PUBLIC UTILITY COMMISSION OF OREGON
STAFF REPORT
PUBLIC MEETING DATE: August 8, 2017

DATE: July 27, 2017

SUBJECT: PORTLAND GENERAL ELECTRIC: (Docket No. LC 66)
Acknowledgement of 2016 Integrated Resource Plan

Figure 1 – Revised Capacity Shortfall Graphic³²

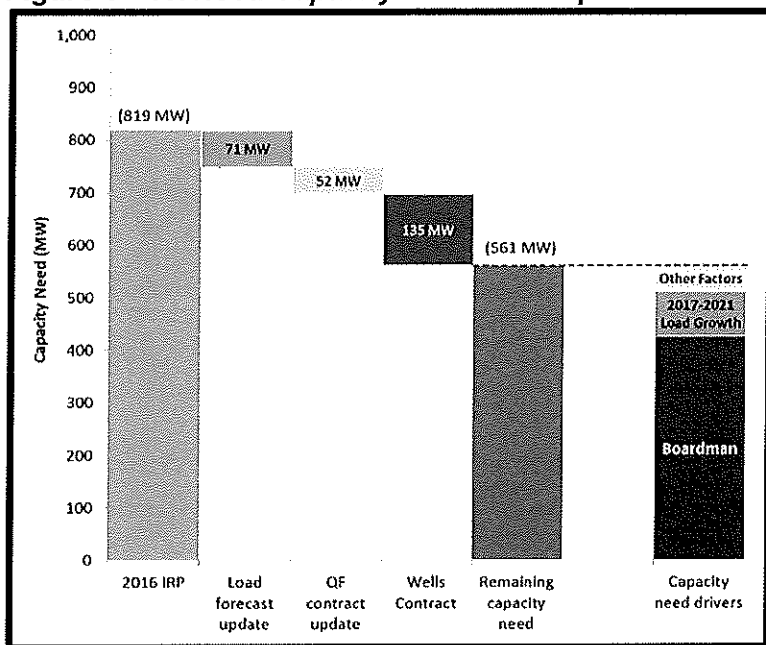
These above-mentioned events had two noteworthy impacts on the 2016 IRP. First, they reduced PGE’s 2021 remaining capacity need to ~561 MW. Second, they extended PGE’s need for Renewable Energy Certificates (RECs) for Renewable Portfolio Standard (RPS) compliance an additional four years into the future, from 2025 to 2029. Nonetheless, all of the Action Items in PGE’s IRP remain largely unchanged. Most notably and concerning to Staff, PGE still continues to seek two categories of large resource acquisitions, one of which is for the primary purpose of meeting a distant regulatory compliance need, not a near-term actual energy or capacity need.
